Permit of Authorization to Construct an On-Site Sewage Facility Permit Valid For One Year From Date Issued

*** COMAL COUNTY OFFICE OF ENVIRONMENTAL HEALTH **REVISED** APPLICATION FOR PERMIT FOR AUTHORIZATION TO CONSTRUCT AN

On-Site Sewage Facility Application and Design

Design Report On-Site Sewage facility Aerobic Wastewater Treatment System Utilizing Surface Spray Application

155 River Star Drive New Braunfels, Texas 78132

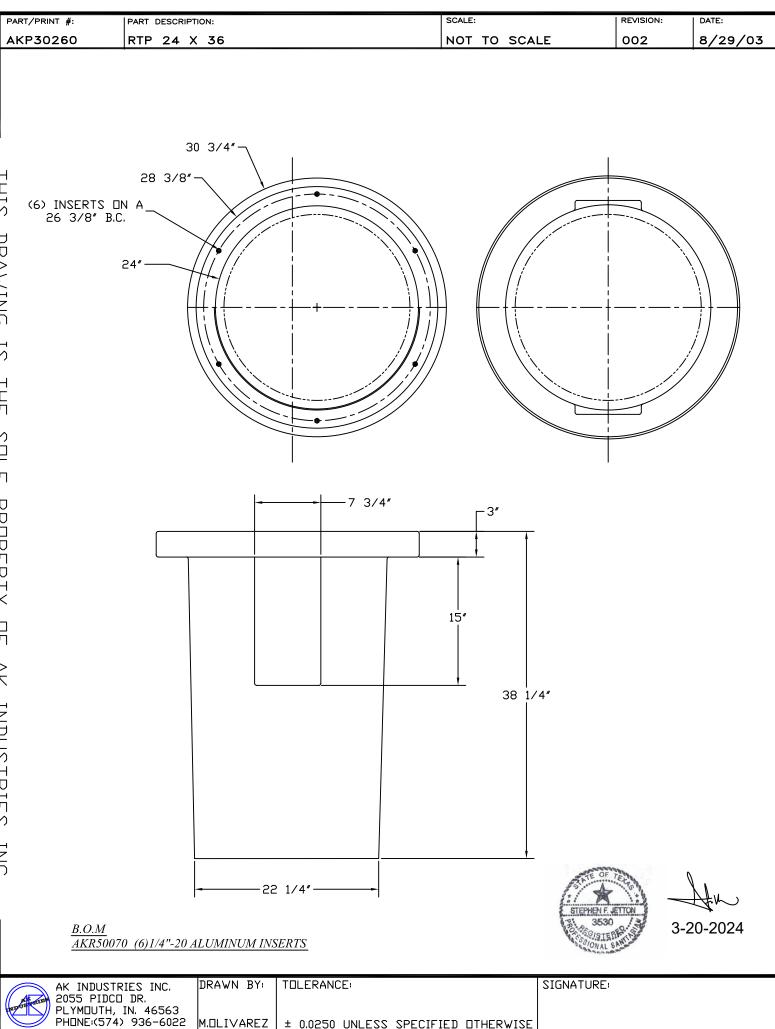
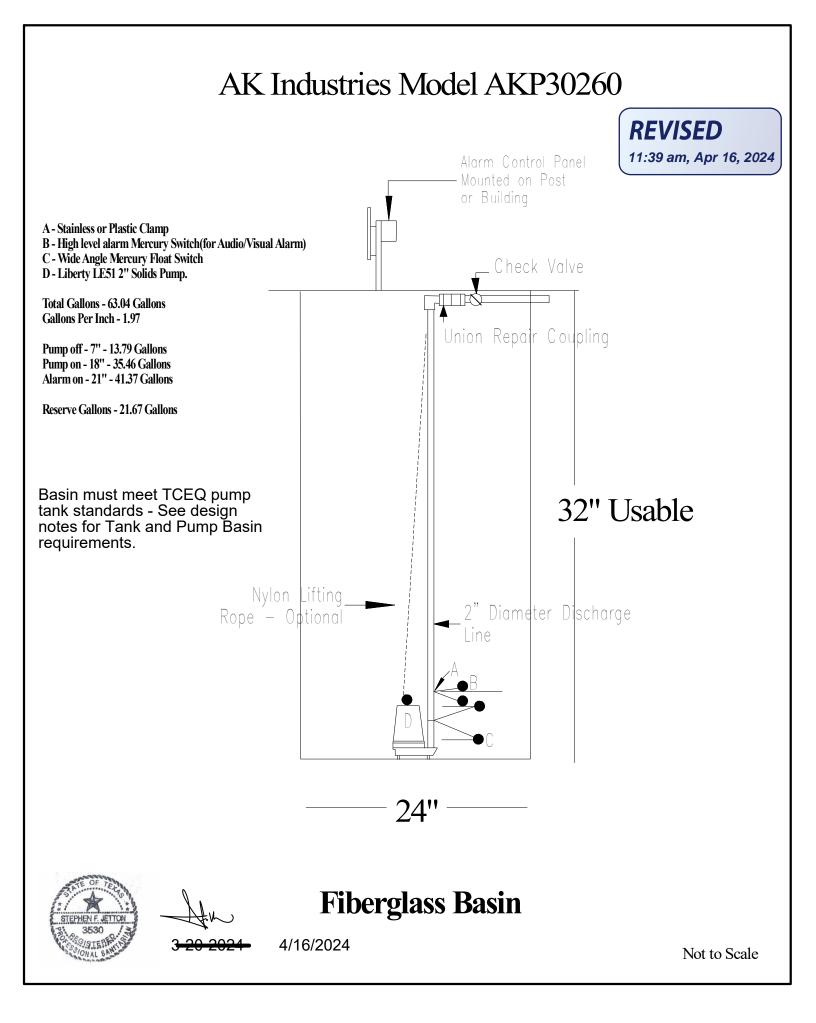
- The owner name on the permit application must include all property owners shown on the recorded deed. Please add Connie Covey to the permit application. Her signature is also needed on the permit application.
- 2. Include the single family residence information on the permit application.
- Submit a notarized Affidavit verifying that both the 4 bedroom 2400 sq. ft. residence and the garage workshop will be for the exclusive use of members of the same single family household.
 - 4. Verify if the fiberglass basin selected meets TCEQ pump tank standards (water tight, etc.).
- Maintain the required 20 ft. setback from the edge of the spray areas to the property lines.
- 6. Revise as needed and resubmit.

Maintain 1' from all Utility Easements. Maintain 20' from all Property Lines. Maintain 10' from all Potable Water Lines.

Typical Pump Tank Cross Section

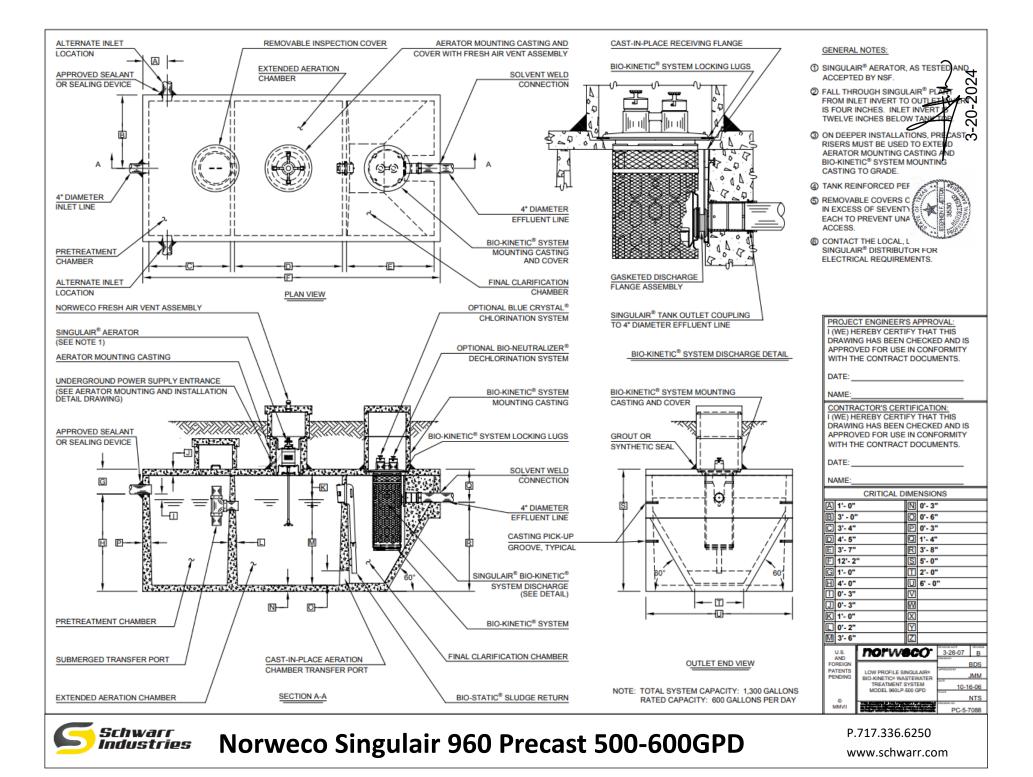
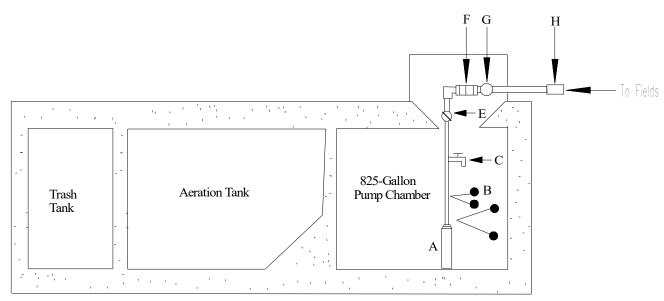
The house must also be included on the type of construction (see highlighted) on the avached permit application. Be advised the pump tank/basin must also contain an audible and visible high water alarm, etc. as per 285.34.

4. This basin meets all TCEQ requirements. I added a note in the cross section and added basin to the design note requirements.
